Harbour Energy Proposed Protective Provisions

Shown as mark-up to the Harbour Energy Without Prejudice Protective Provisions as Submitted by the Applicant at DL5

Protective Provisions Plan Spirit and Harbour

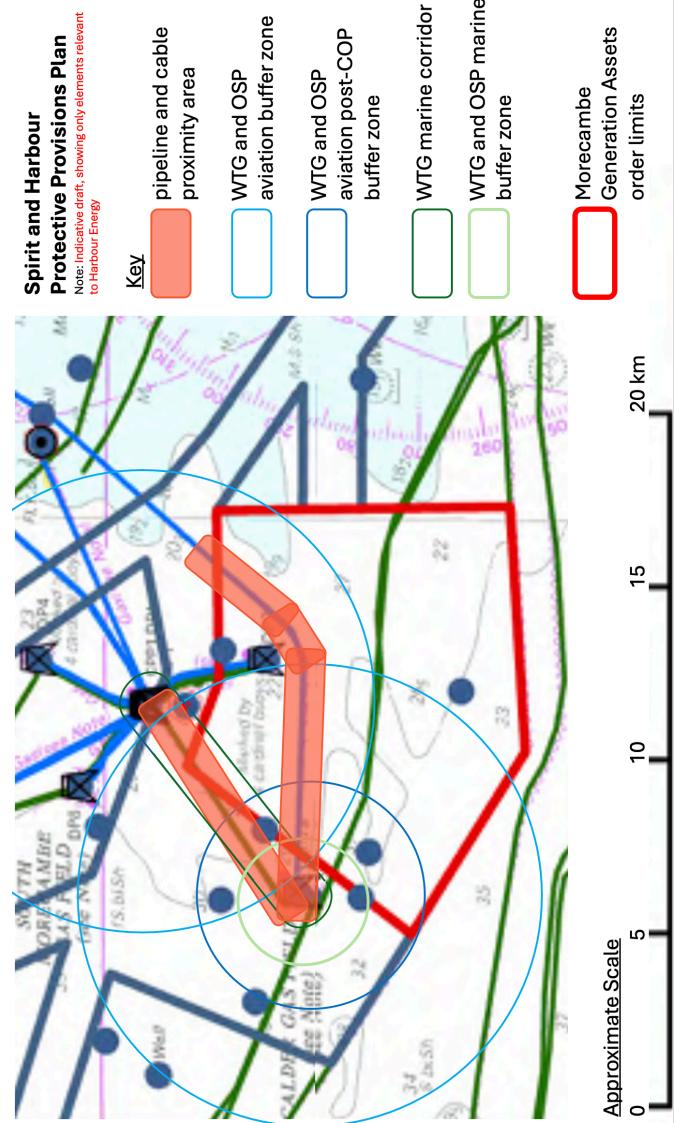
"WTG and OSP aviation post-COP buffer zone" means a circular area of one point nine nautical miles (1.9 nm) of clear airspace measured from the nearest outer extremity edge of the Calder Platform to any tip from any wind turbine generator located within the order limits and extending vertically from mean sea level, shown edged blue and annotated and shown as the WTG and OSP aviation post-COP buffer zone on the Spirit and Harbour Protective Provisions Plan;

Commented [HE7]: In the interests of co-existence, and as a development from earlier submissions, Harbour Energy is willing to accept that, with suitable compensation provisions, post-COP decommissioning work could be undertaken with rotor tips no nearer than 1.9nm. As clearly set out in Harbour Energy's Written Representation (REP1-102), the AW169 aircraft used in the East Irish Sea require an obstacle-free distance of 1.9nm upwind of a helideck in order to execute a take-off or a missed approach should one engine become inoperable. The Applicant has challenged this distance but Harbour Energy re-iterates that this distance has been confirmed by our aviation specialists by reference to the performance graphs in the aircraft operating manual and also by the helicopter operator operating these aircraft on behalf of Spirit Energy, including those to the Calder Platform. In support of this change from Harbour Energy's DL5 submission (in which 3.76mm was required for both pre-COP and post-COP operations), the drafting of these protection.
